**RESPONSE TO ASSESSMENT MANAGER'S INFORMATION REQUEST
DEVELOPMENT ASSESSMENT RULES 2017 PART 3 S13
DEVELOPMENT APPLICATION FOR A DEVELOPMENT PERMIT FOR A
MATERIAL CHANGE OF USE FOR AN INDUSTRY DEVELOPMENT AT
167-191 CHRISTENSEN ROAD SOUTH, STAPYLTON
(LOT 304 SP329491)**

PROPOSED INDUSTRIAL BUILDINGS

LOT 304 CHRISTENSEN ROAD, STAPYLTON, QLD, 4207

1 BUILDING ELE 9 (REAR - PUBLIC OPEN SPACE) - PART 1

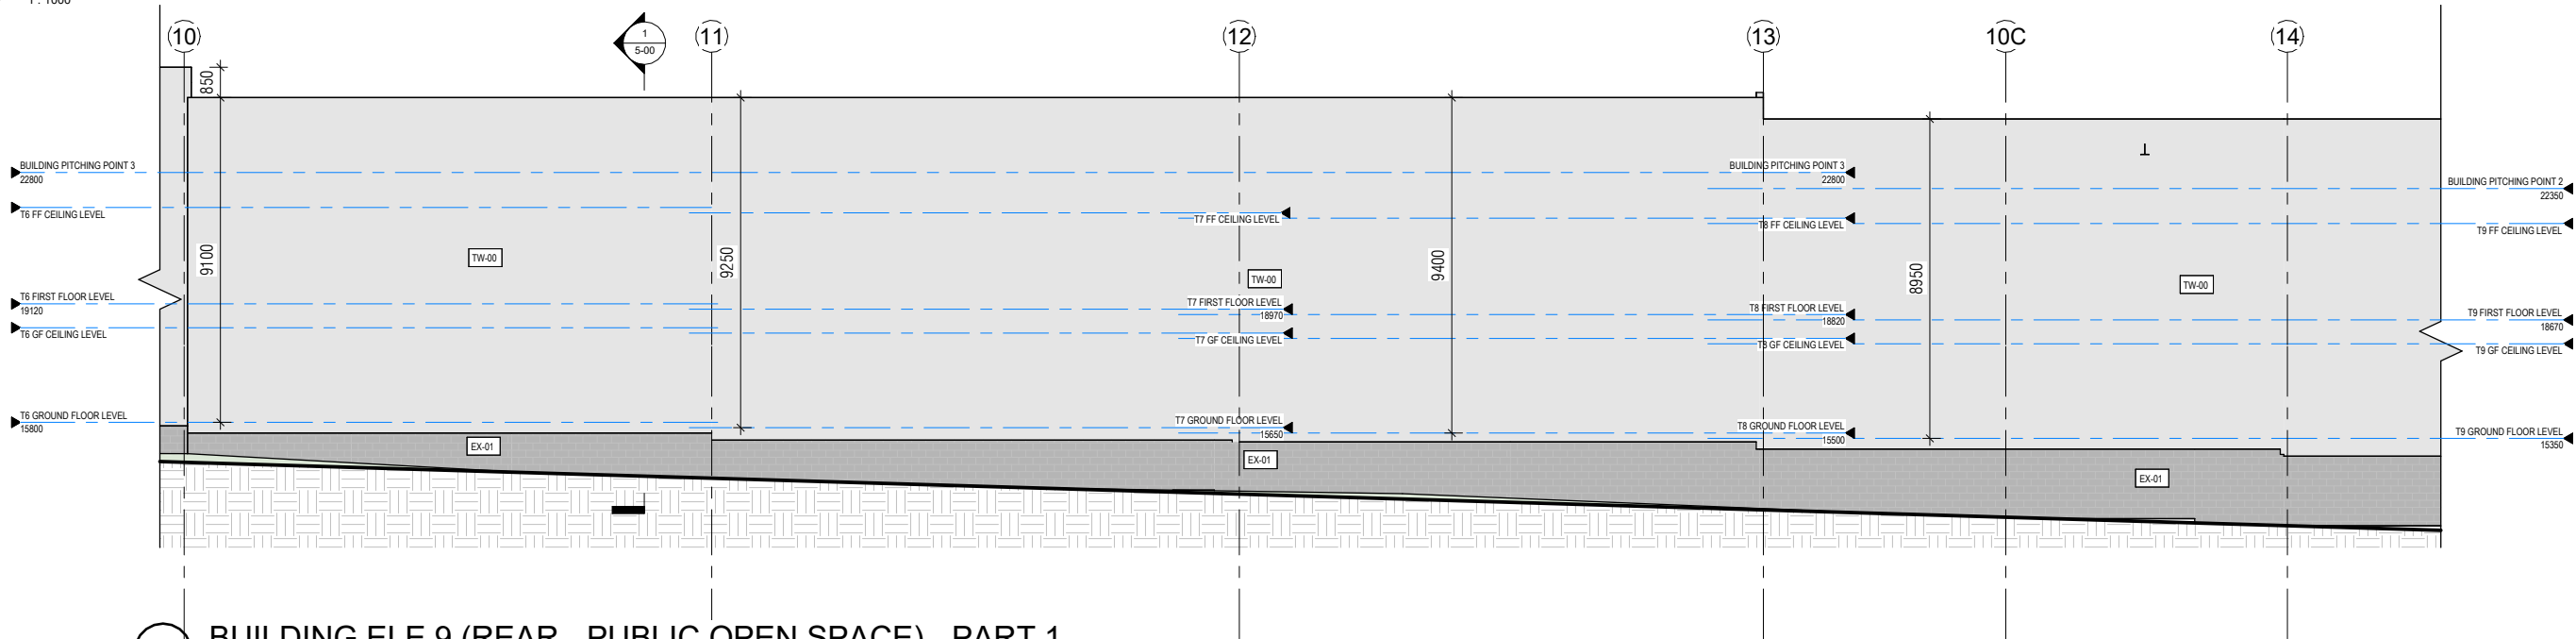
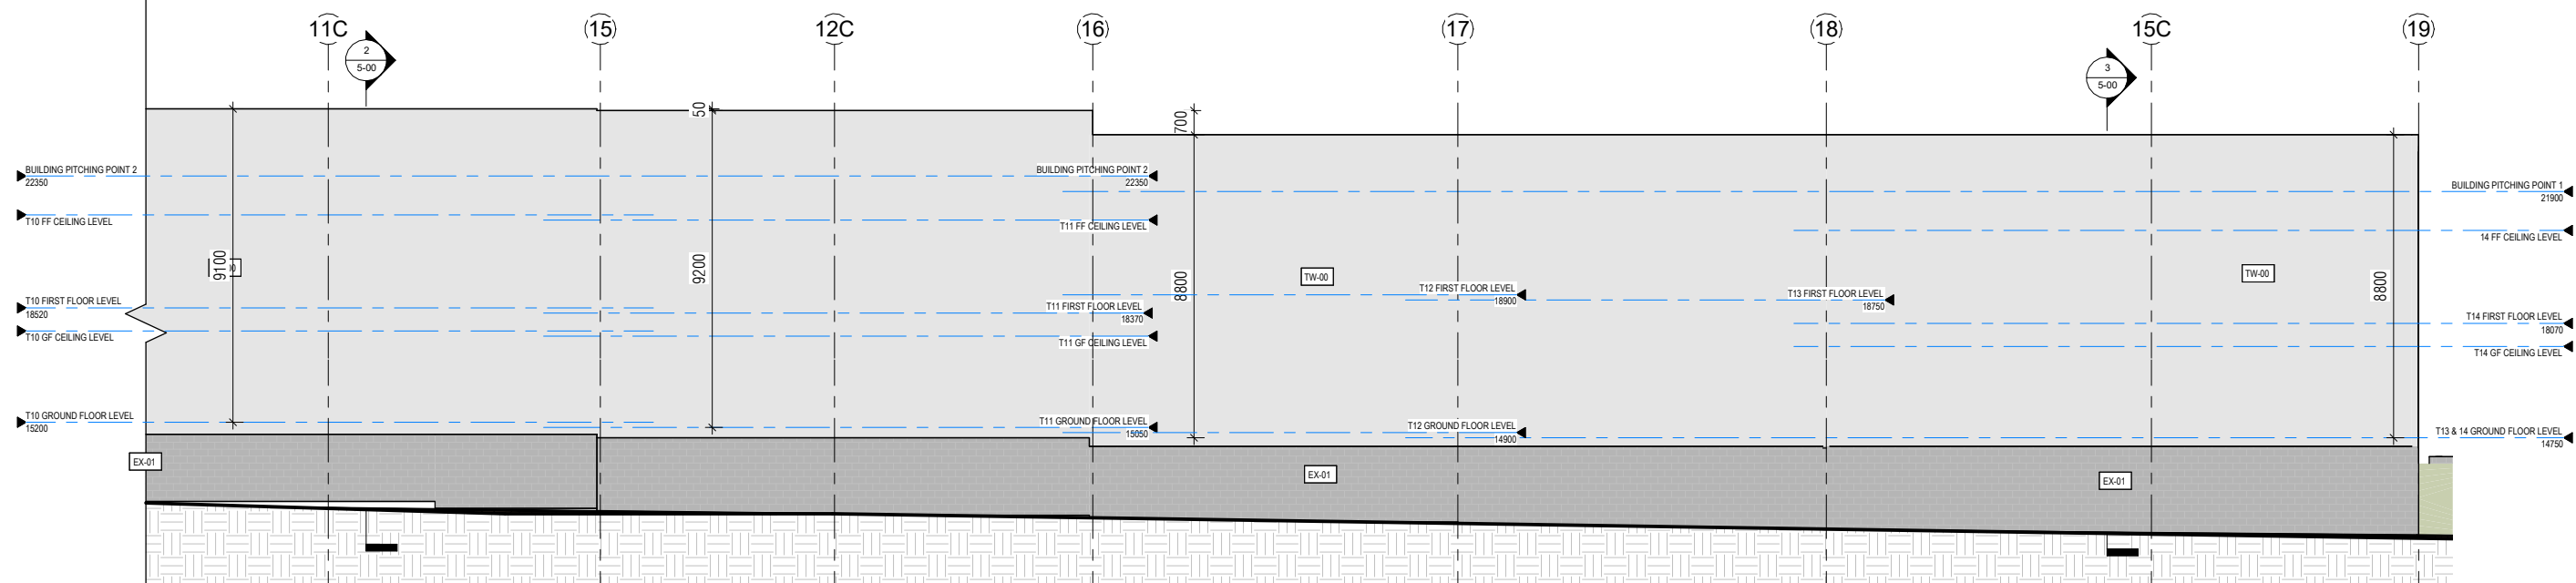
AS4.3 of the M38 Industrial Estate Place Code requires a 3m setback from the common boundary of public open space which includes a fence and landscape buffer strip. Further to this PC14 and PC15 requires buildings to be sited to prevent potential conflicts between uses and a clear separation between public access areas and areas set aside to service the building. Further to this, condition 50 of MIN/2023/64 requires retaining walls to be setback from the public open space by 600mm in accordance with Planning Scheme Policy 11 - Land Development Guidelines.

The applicant is requested to demonstrate through amended plans how the buildings will be maintained and adequately setback from proposed Lot 904 to be dedicated as public open space for conservation purposes in accordance with existing conditions of approval as well as the M38 Industrial Estate Place Code. All bushfire management requirements requested as part of Bushfire Assessment information request items are to be undertaken within the development footprint and not impact upon proposed Lot 904.

In response, the proposal has revised the rear boundary setback to 200mm, which reduces the gross floor area loss to 34.5m².

It is commonplace for industrial developments to be built to boundary, particularly where adjoining a conservation/open space lot. There are endless examples of this throughout the City of this occurring and maintenance of the rear boundary/side boundary walls and retaining walls has never been questioned. For completeness, a structural engineers statement has been included in **Attachment 5** confirming no maintenance of the wall will be required.

CHRISTENSEN ROAD STAPYLTON
OPERATIONAL WORKS - PLANTING PLAN 1-6

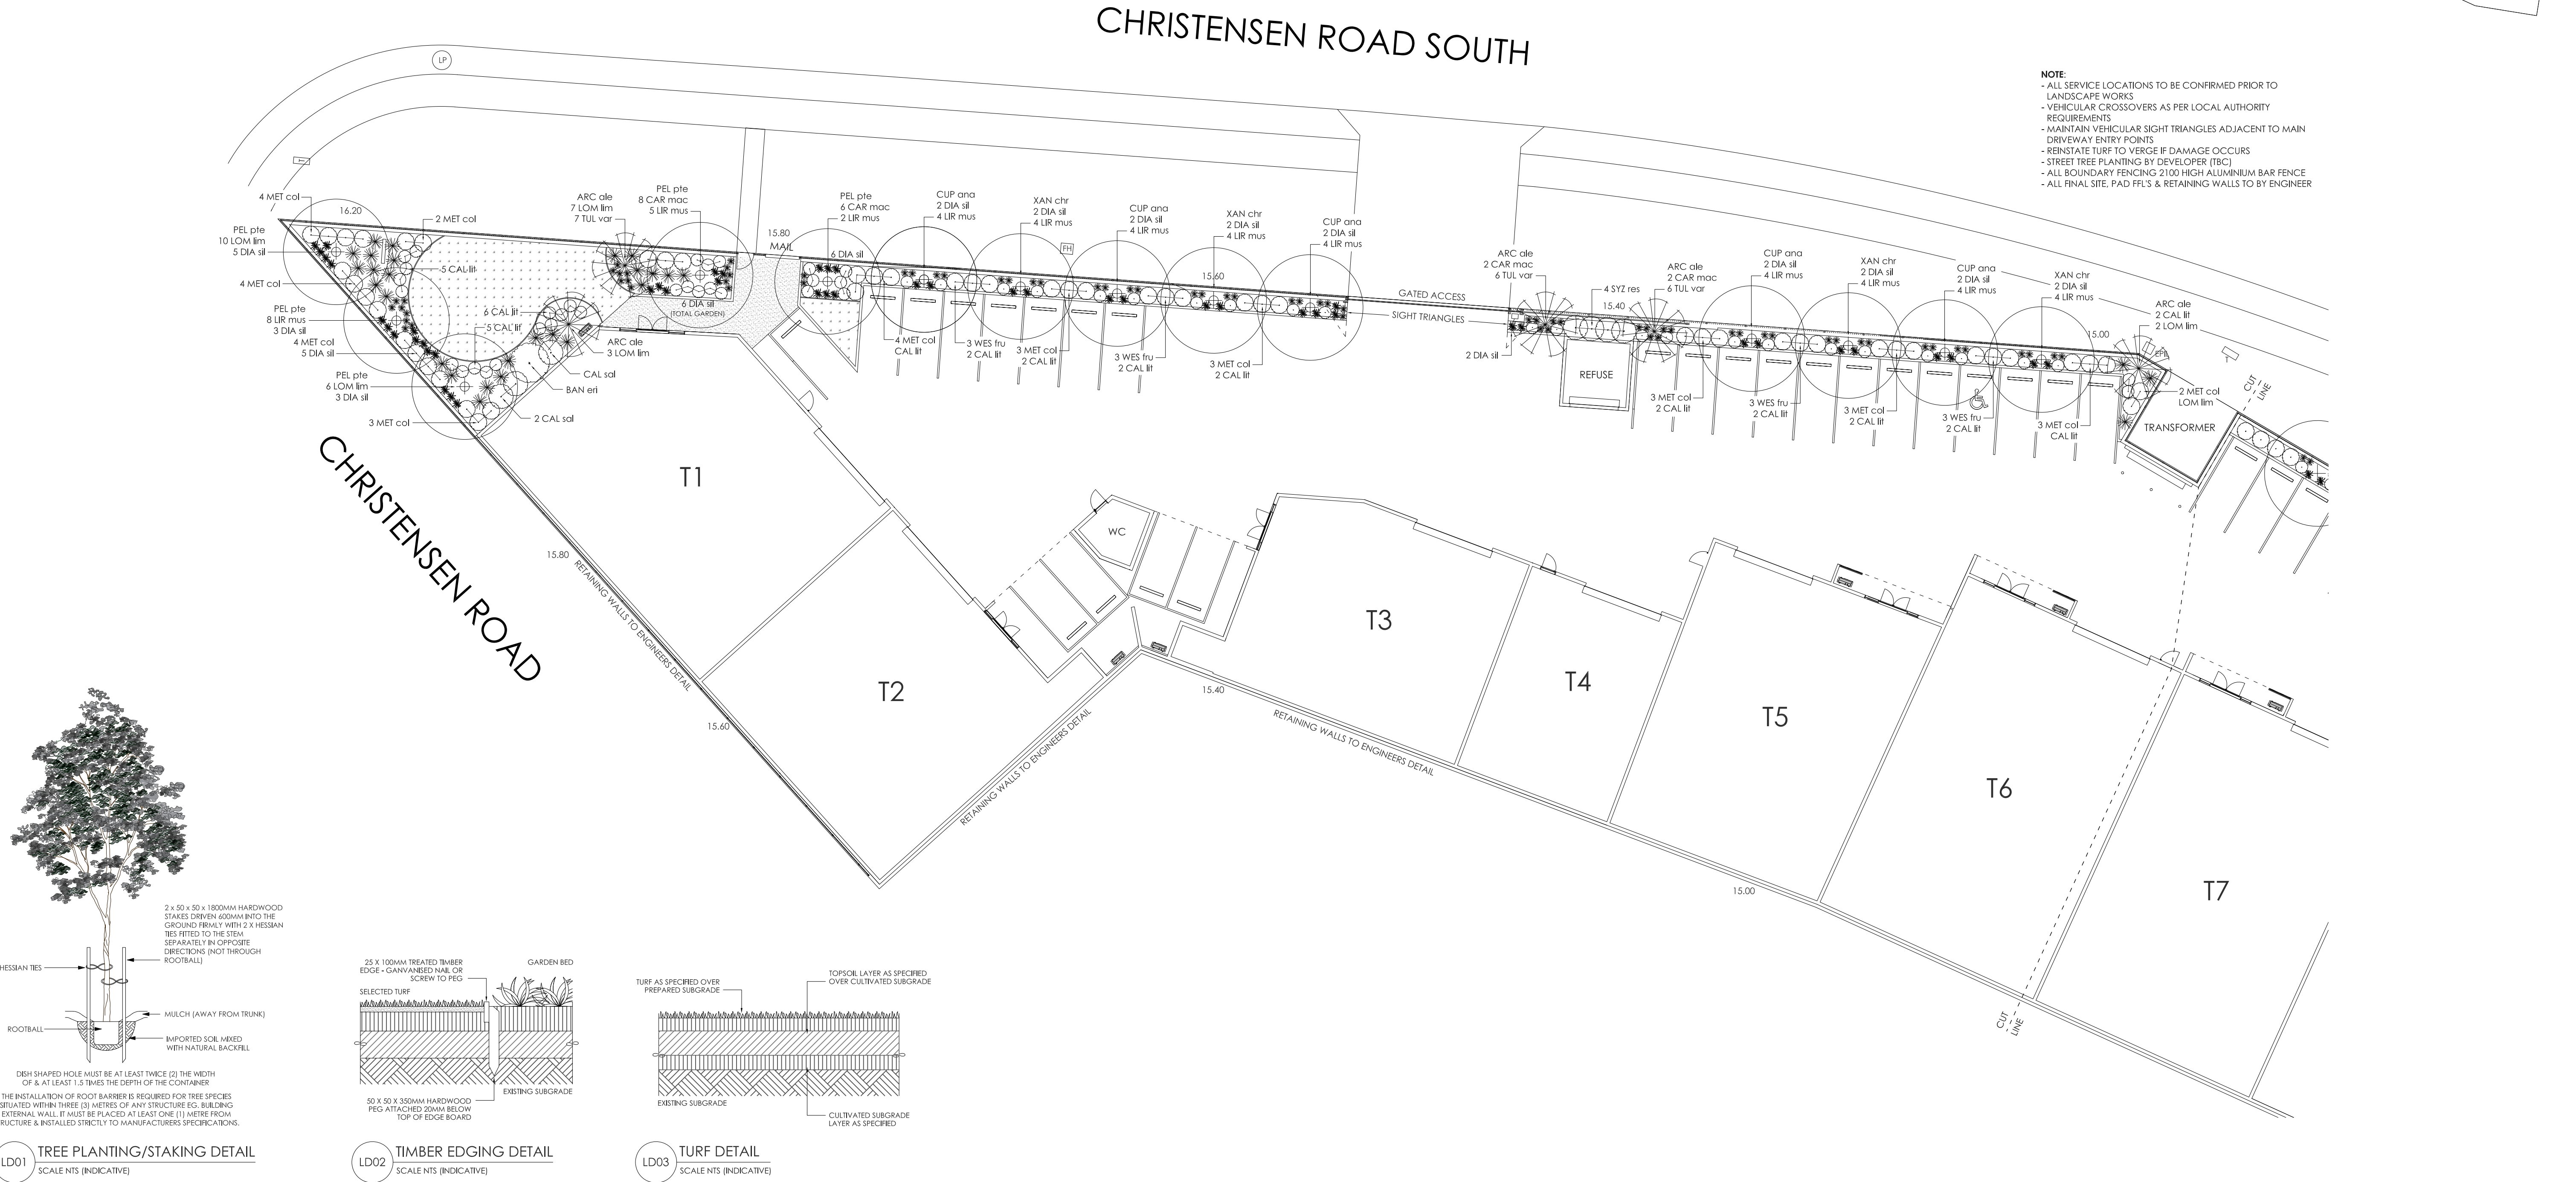
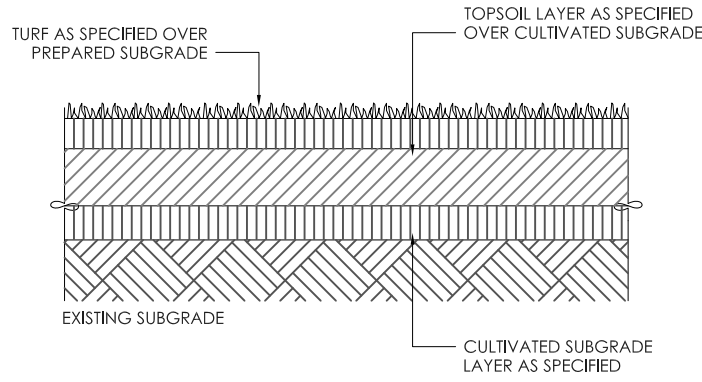
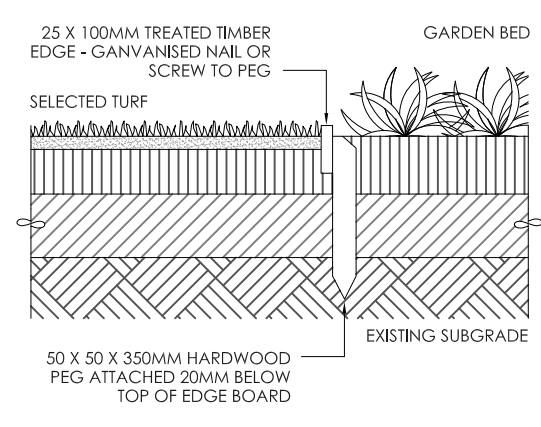
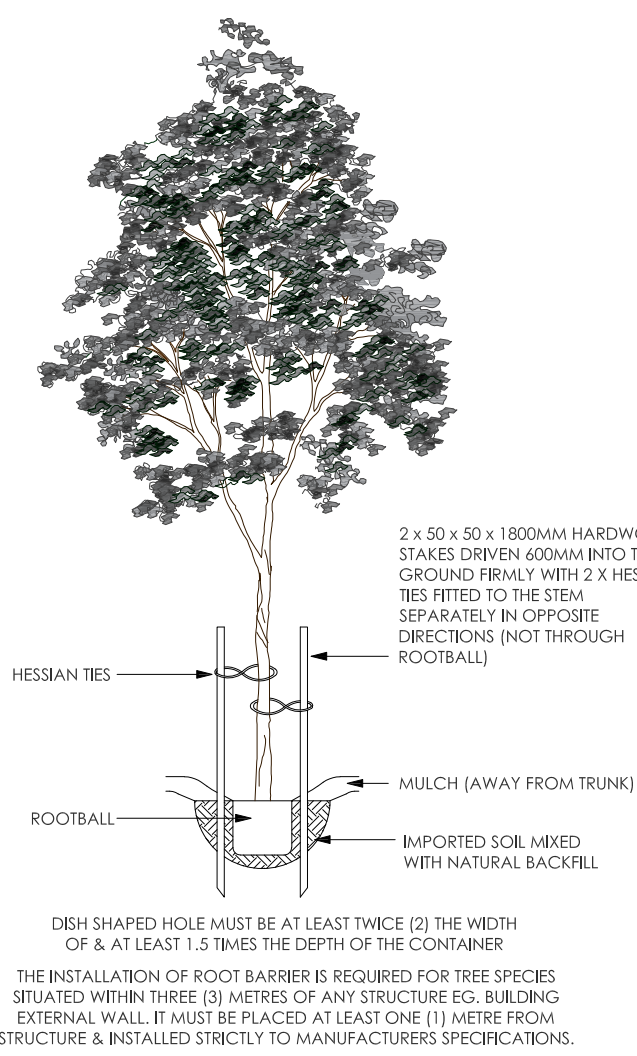
It is requested that the SLI is amended to clearly detail a minimum 1.5m wide landscape buffer along the subject site frontage clear of car parking. All other relevant plans are requested to also reflect this. Include the landscape treatment of the balance of bio-basin areas not approved as part of OPW/2023/1493 within the amended SLI.

The carparking spaces have been amended to reflect a minimum length of 5.4m with no overhang to the frontage landscape buffer. The resulting outcome is that the frontage landscape buffer achieves a minimum width of 1.5m and is suitable for successfully establishing plants and trees.

Further to this, planting of the batters to the bioretention basin have been incorporated within the revised statement of landscape intent.
